# PHASE 3 RENOVATION UPDATE: July 2024

# BPL Phase 3: Punch List As of 7/2/24 Attention: PCI DAILEY

#### BALDWIN PUBLIC LIBRARY PUNCH LIST (7/9/2024)

13.

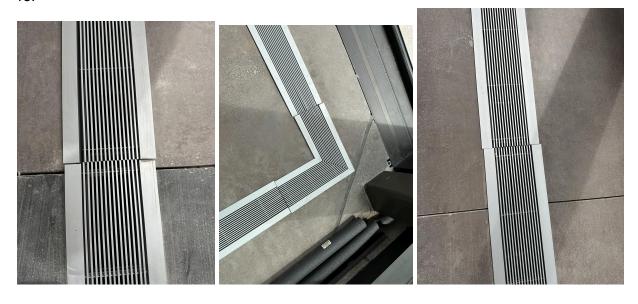
- 13. Clean gasket at top of sorting room glazing
- 14. Remove trim at column at circulation + seat gasket at glazing at top of stairs
- 15. Finish wood blocking at book sorting chute

Punchlist Item No. 2

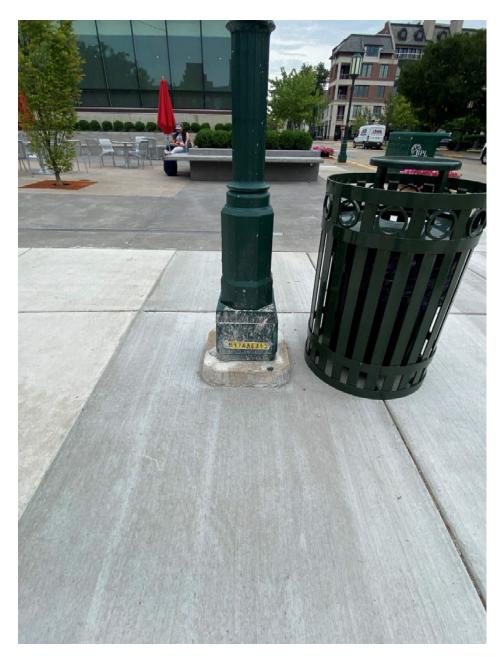
- 1. An as-built needs to be submitted to the City and includes information about as built information about grades, inverts, storage volume, etc.
- 2. ADA truncated domes are the wrong type and have concrete on them. These needs to be cleaned.

- 3. The color concrete has issues with the finish.
- 4. Clean concrete slurry off the streetlight pole.
- 5. The concrete patch repair needs to be extend further out to the middle of the road and west due to not saw cutting the prior to removal.

Punchlist Item No. 8

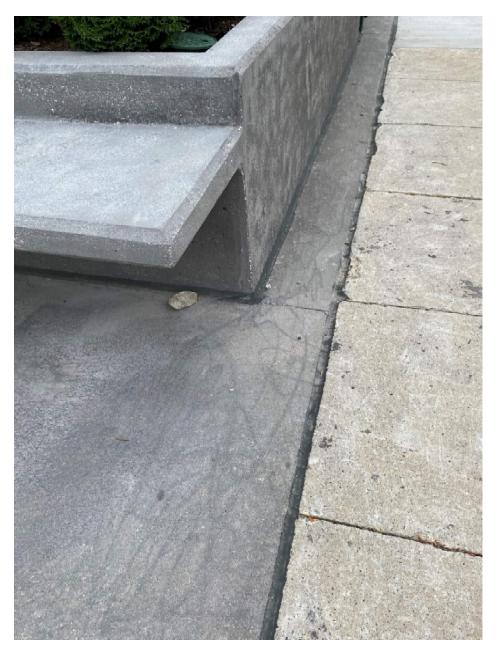
- 8. Certain new sidewalk slabs exceed ADA requirements of 2% cross slope.
- 9. Existing sidewalk slab were chipped during the construction of new and needs to be addressed.

Punchlist Item No. 10

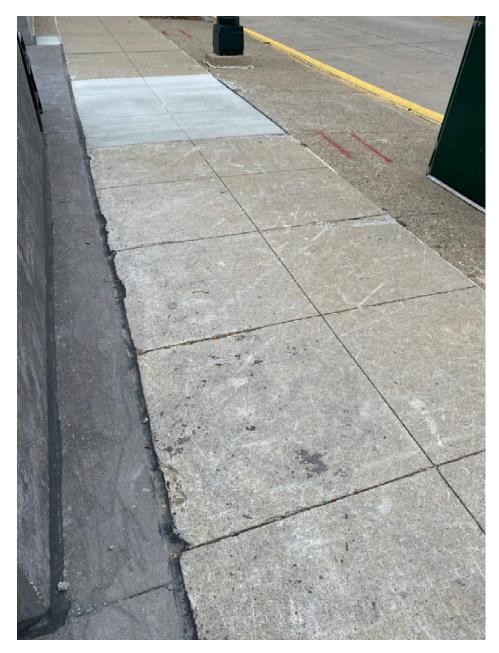
- 10. There is uneven concrete edge were the new color concrete meets existing sidewalk near library drop box.
- 11. Existing sidewalk slabs to remain were either damaged and chunks missing that need repairs.

Punchlist Item No. 11

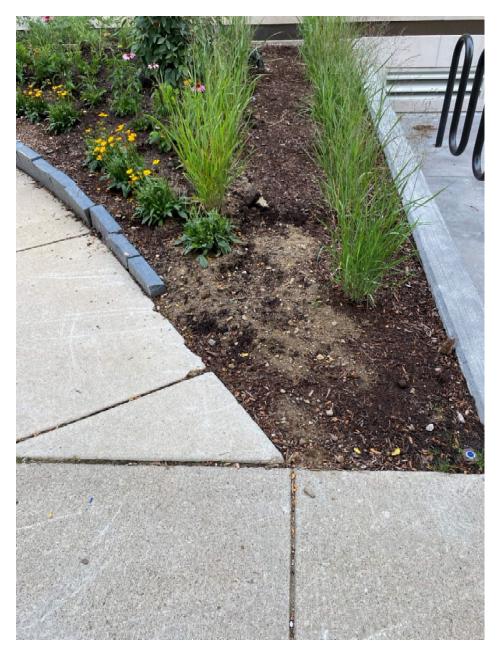
- 12. Existing brick edge for landscaping needs to be reinstalled
- 13. The newer concrete color curb west of the entrance is cracked and needs repair.
